## **SHEPPARD ENGINEERING, P.C.**

Re: I3 Detroit  
1481A Wordsworth  
Ferndale, MI 48220  
SEPC Job No. 15-053-A

At your request, I met you at the above referenced project on March 26<sup>th</sup>, 2015, to inspect a sag in a portion of the ceiling in the classroom as well as step cracks in the concrete masonry wall above. The area of sag is located where a wall had been previously removed. At the time of the inspection, two access holes were cut in the gypsum ceiling of the classroom to determine the framing above. It was determined that a steel lintel exists parallel to the wall that had been removed, offset 1'-4" toward the offices. One end of the lintel was found to be inadequately supported by 2x6 ceiling joists supported by interior bearing walls, one of which was the wall recently removed. It was indicated at the time of the inspection that the end of this lintel be temporarily shored immediately.

PARTIAL FIRST FLOOR PLAN

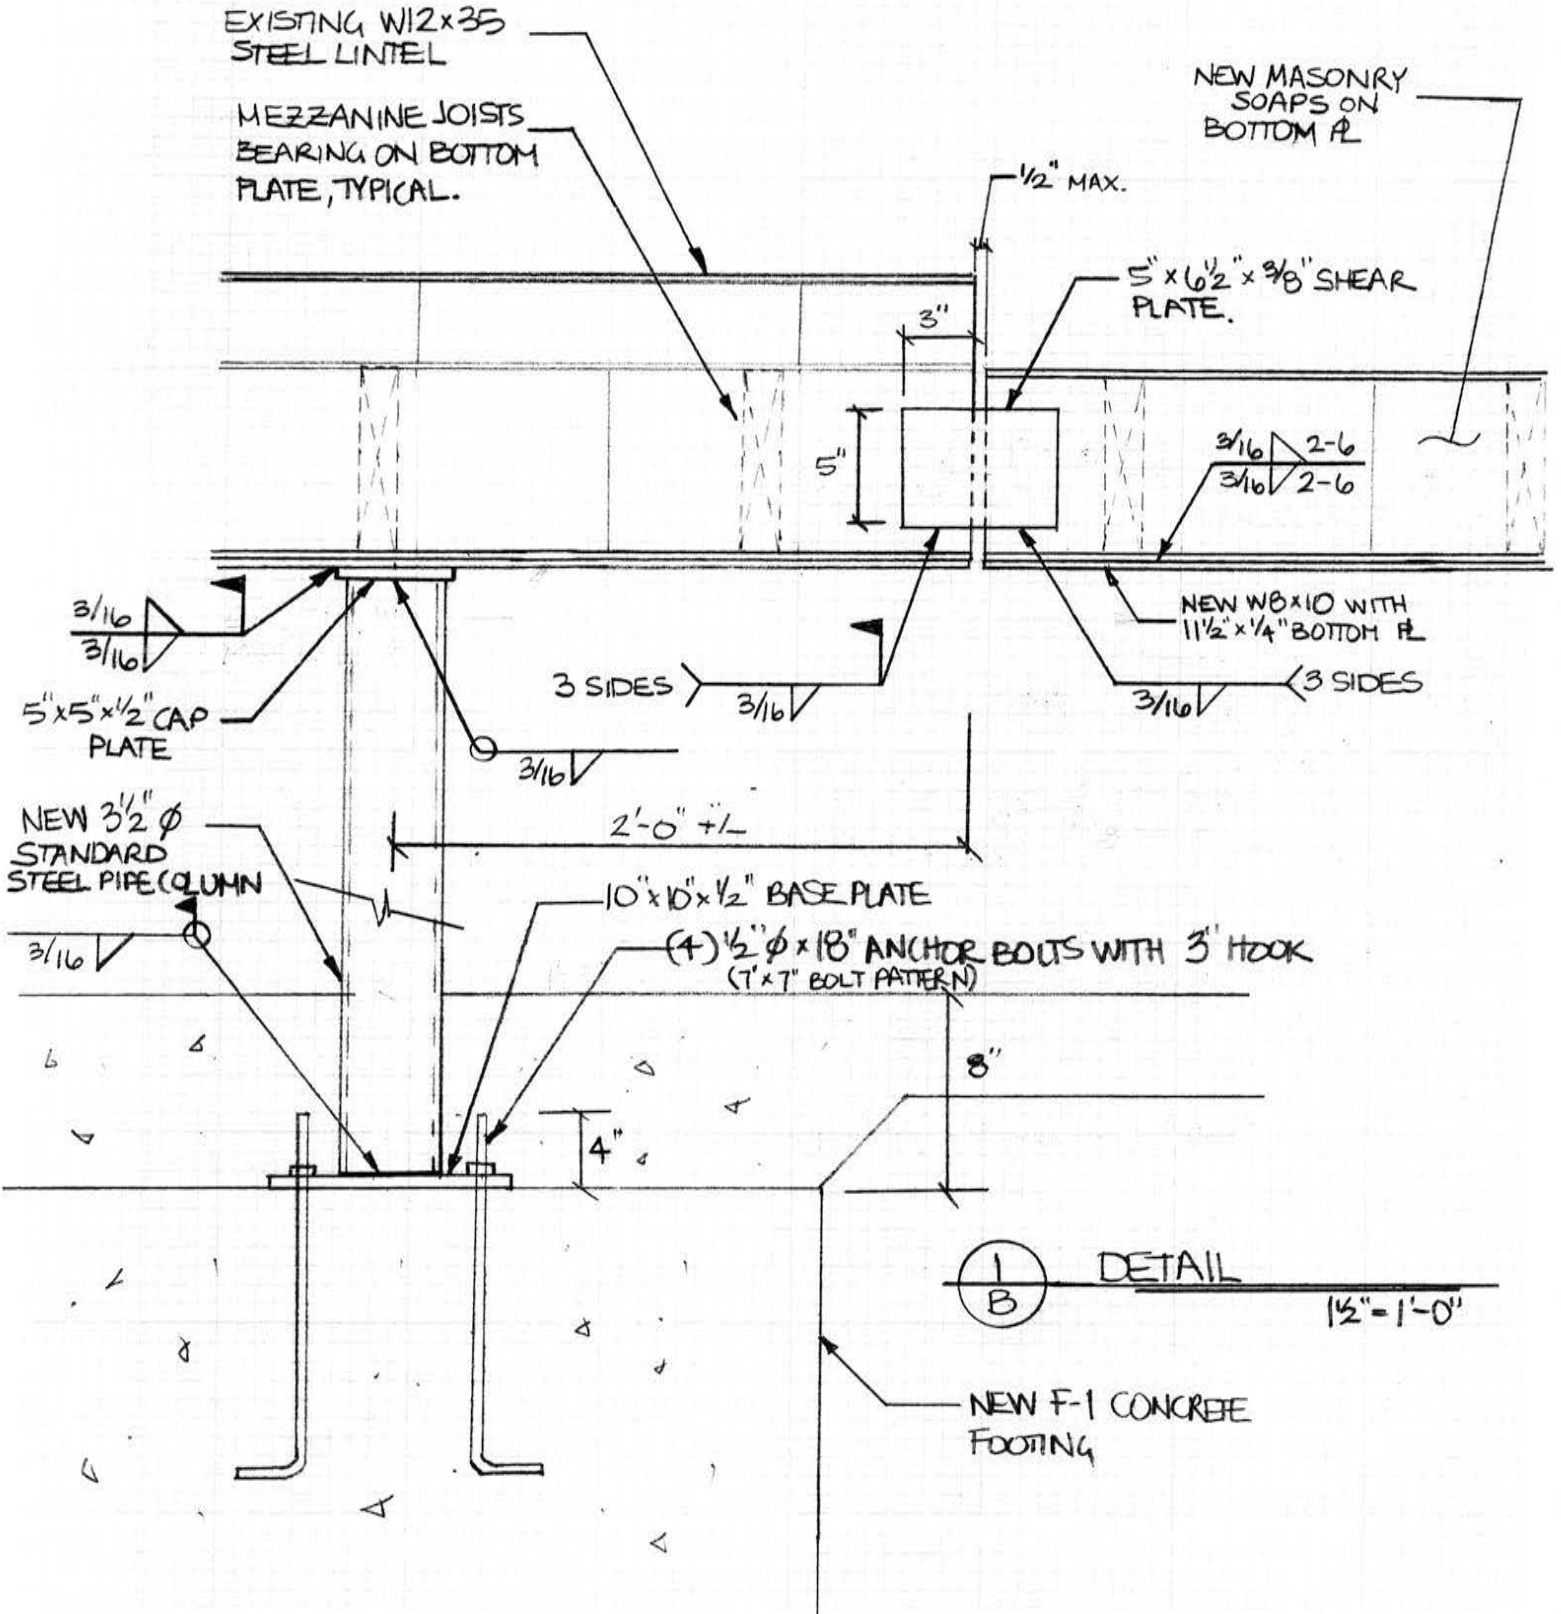
We designed a new column and footing to support the lintel near its inadequately supported end. The column will be offset approximately 2' from the end of the lintel to align with the entry hallway/office wall. A new lintel has also been designed to span from the end of the existing lintel to the CMU wall to support the 2'-8" portion of CMU wall above that currently does not have an adequate support in place. The existing lintel shall be slowly jacked back up to its original position before the new column is installed. See the attached sketches for the repair design.

The current support (2-2x6 beam) does not suffice for the lintel support or to support the 2x ceiling joists over the hallway. After the new column is installed, the 2x6 beam and the 2x ceiling joists shall be completely removed. Gypsum can be attached directly to the underside of the mezzanine joists for the classroom ceiling. New 2x4 joists may need to be installed from the bottom plate of the steel lintel to the office wall to flush out with the remainder of the classroom ceiling.

C-1:  $3\frac{1}{2}$ "  $\phi$  STANDARD STEEL PIPE COLUMN WITH 10" x 10" x  $\frac{1}{2}$ " BASE PLATE WITH (4)  $\frac{1}{2}$ "  $\phi$  x 18" ANCHOR BOLTS WITH 3" HOOKS (7" x 7" BOLT PATTERN)

F-1: 3'-6" x 4'-0" x 2'-0" THICK CONCRETE FOOTING WITH (5) #6 BARS EACH WAY AT BOTTOM (4" OF COVER REQUIRED) TOP OF FOOTING IS 8" BELOW FINISHED FLOOR.
